# City of Medford RWRP Proposed NPDES Permit Amendments to Fact Sheet (Evaluation Report)

Oregon Department of Environmental Quality  
Western Region Medford Office  
221 Stewart Avenue  
Medford OR 97501

Date: December 12, 2011

Figure 2-4: Medford RWRf Flows

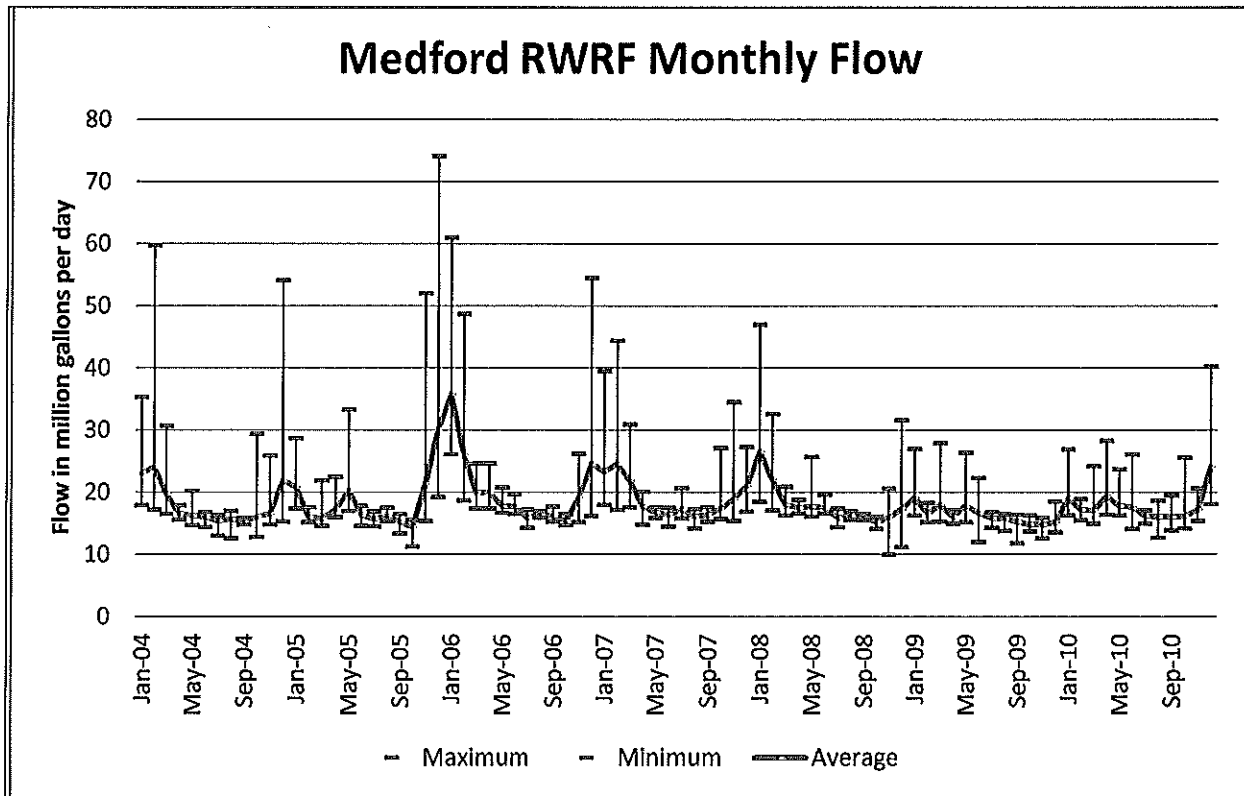
Page 5, Paragraph 1, last sentence: The last paragraph is changed as follows:

"Figure 4-4, p. 2, above shows that the average dry weather flow remained below 20 million gallons per day (MGD) during the last seven years. The highest average dry weather flow was in 16.6 MGD in 2007. The highest monthly average flow (35.8 MGD) occurred in January 2006 and was more than twice the average dry weather flow. The peak day flow of 74.1 MGD occurred on December 31, 2005 and was almost 4.5 times the dry period average flow. This indicates relatively low I/I as compared to other facilities in Western Oregon."
